U S NAVY RESPONSE TO REGULATOR COMMENTS TO RCRA FACILITY INVESTIGATION  
REPORT ADDENDUM AREA OF CONCERN 562 (AOC 562) ZONE E WITH TRANSMITTAL  
CNC CHARLESTON SC  
11/14/2002  
CH2M HILL

AOC 562 Zone E

Response to Comments on RFP Report Addendum

**Re:** CH2M-Jones' Responses to Comments by SCDHEC regarding the *RFI Report Addendum, Area of Concern 562, Zone E, Charleston Naval Complex* (Revision 0)

FIGURE 10.30.2  
WIPE SAMPLE LOCATIONS  
AOC #562  
SUBSTATION  
BUILDING 84

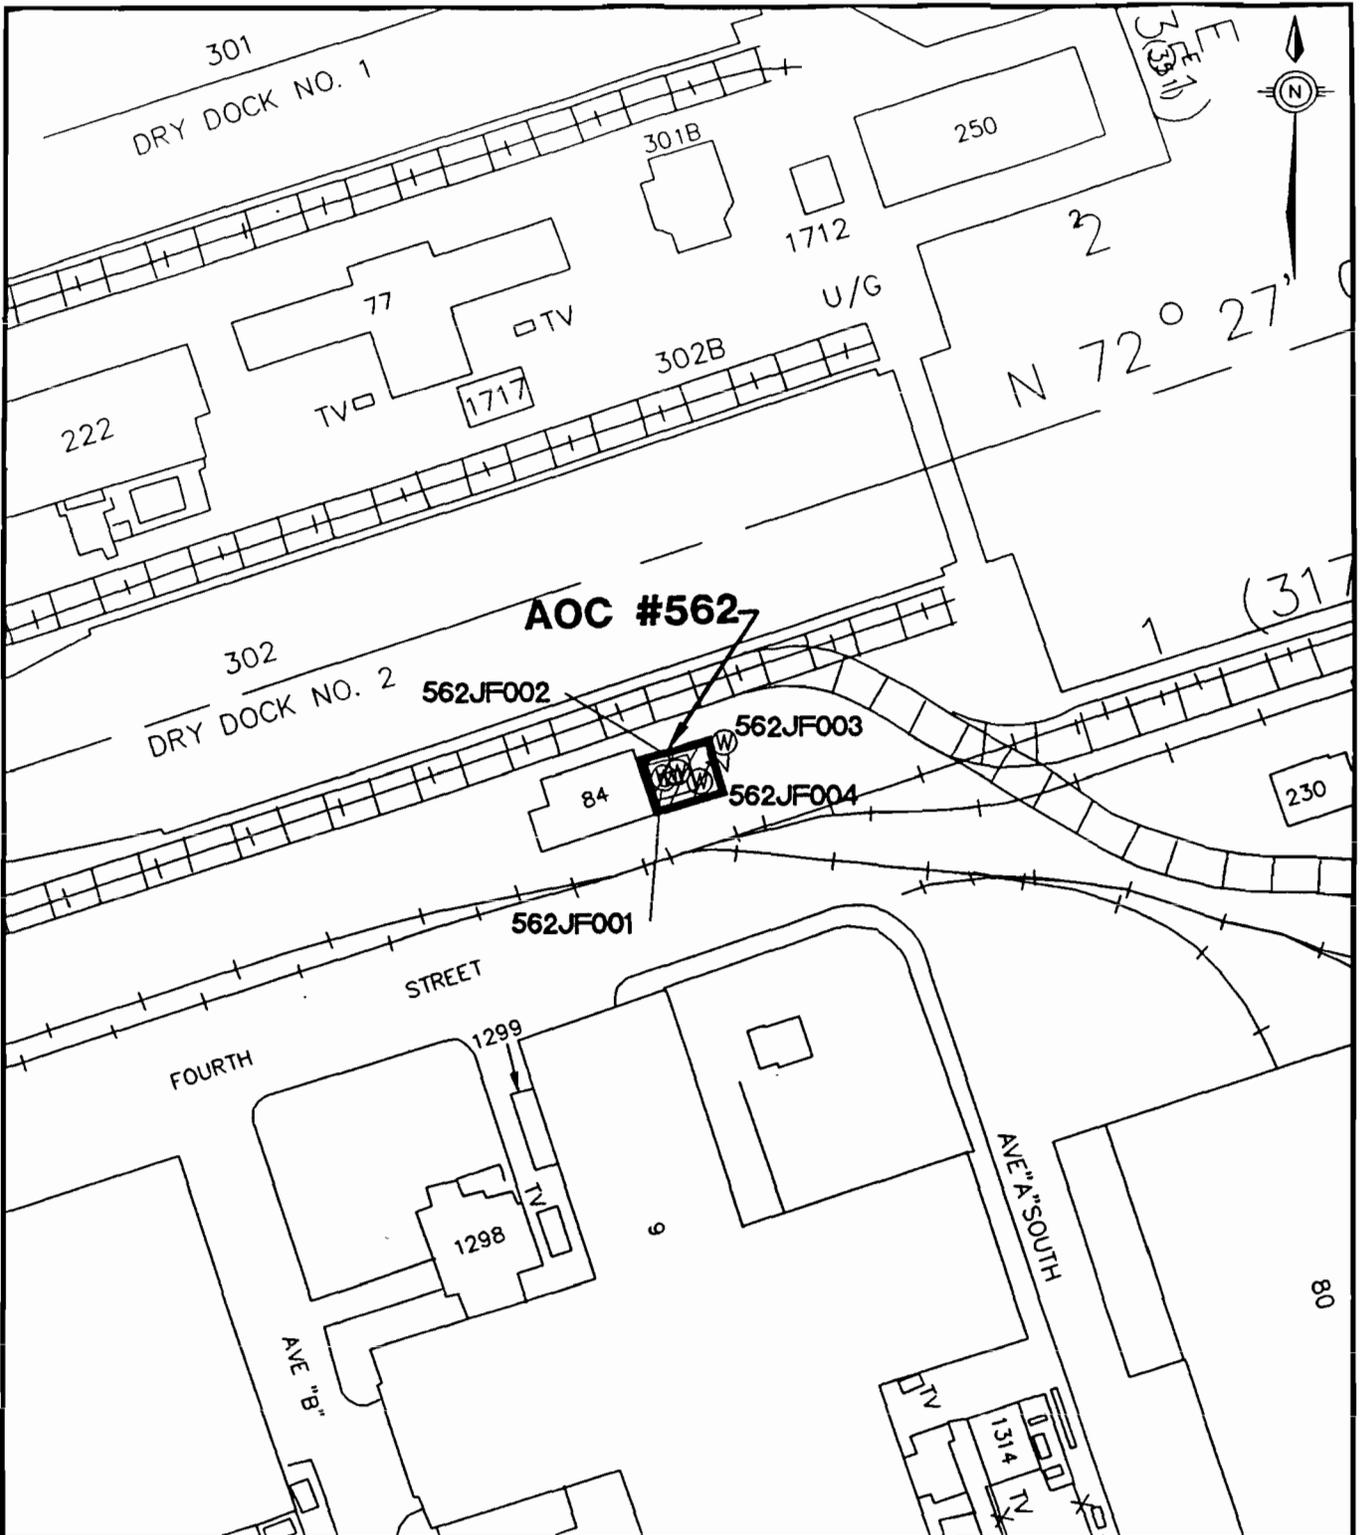
This section presents the results of the wipe sampling conducted in the transformer storage area. Sample locations were biased toward areas of the highest possible contamination. Only one of the four samples had a detectable quantity of PCBs at 9.8  $\mu\text{g}/\text{cm}^2$ . However, the location of this detect is not presented in the documents. Please indicate where this single detection occurred.

Furthermore, there is no rationale as to why this detection is not of concern. The Department recommends using 40 CFR 761.125(c)(4)(ii) under the Toxic Substance Control Act (TSCA) as a reasonable screening tool to determine if additional action is required to remove residual PCB contamination from solid surfaces. This section of TSCA states that, for non-restricted access areas, high-contact outdoor solid surfaces shall be cleaned to 10  $\mu\text{g}/\text{cm}^2$ . Considering the wipe samples have met this criterion, the surface of the storage area does not require any additional cleaning. Please provide this rationale or other rationale deemed appropriate by the Navy to demonstrate that the wipe sample results are not of concern. Please note that this comment applies to any future sites for which PCB wipe sampling was conducted.

*AOC 562 is an electrical substation set on a concrete slab on which three transformers were previously located. The wipe samples were collected at the locations shown in Figure 10.30.2 from the Zone E RFI Report, Revision 0 (a copy of the figure is attached to this response).*

*In an effort to ascertain which of the four wipe samples had the PCB detection, CH2M-Jones reviewed Appendix H of the Zone E RFI Report (which contained all of the analytical data summaries for samples collected and analyzed during the RFI) as well as the analytical database we received from EnSafe. We were unable to locate the wipe sample results in either of these sources, and consequently are unable to identify which wipe sample had the detection. However, because the detection was below the TSCA wipe sample screening level discussed below, this does not appear to be a significant issue.*

*With regard to the question as to why no rationale was provided as to why the PCB detections were not of concern, the answer is that there are no RCRA Corrective Action risk-based criteria to compare to these values. Note that the TSCA-referenced cleanup value (10  $\mu\text{g}/100\text{ cm}^2$ ) is not a risk-based concentration.*

*The Navy and CH2M-Jones do not have a significant concern about using the TSCA remediation criteria as a screening step at this particular site for evaluating wipe samples. However, we do have a concern about the 10  $\mu\text{g}/100\text{ cm}^2$  screening criterion being applied as the only acceptable cleanup/investigation standard for this or similar sites at the CNC.*

*The wipe criteria referenced in 40 CFR 761.125 apply only to spills of PCBs at concentrations of 50 ppm or greater which are subject to the requirements of 40 CFR 761. Therefore, at sites at which there is no evidence that a spill of this nature occurred, we question whether there is a basis to apply or make mandatory the TSCA requirements of 40 CFR 761 as cleanup or investigation criteria.*

*In addition, the 10  $\mu\text{g}/100\text{ cm}^2$  criterion applies to non-restricted access areas, high-contact outdoor solid surface locations. There is no indication that the transformers at AOC 562 meet the criteria for designation as a non-restricted access areas, high-contact outdoor solid surface location. Given the location of AOC 562 in the industrialized portion of the CNC, the term "non-restricted access area" does not appear to apply, as this area is not accessible to the general public.*

*The term "high-contact surface" in an industrial setting refers to a surface which is repeatedly touched, often for relatively long periods of time. Manned machinery and control panels are examples of high-contact industrial surfaces. Examples of low-contact industrial surfaces include ceilings, walls, floors, roofs, roadways, and sidewalks in the industrial area, utility poles, unmanned machinery, concrete pads beneath electrical equipment, curbing, exterior structural building components, indoor vaults, and pipes. The concrete that was wiped would be considered a low-contact surface.*

*A more appropriate criterion for this or similar sites would be the allowable cleanup level for low-contact, outdoor surfaces in restricted areas of 100  $\mu\text{g}/100\text{ cm}^2$ .*

*Because all of the detected concentrations are below both the 10  $\mu\text{g}/100\text{ cm}^2$  and the 100  $\mu\text{g}/100\text{ cm}^2$  criteria, CH2M-Jones agrees with SCDHEC that the detected PCBs in the wipe samples are not significant.*
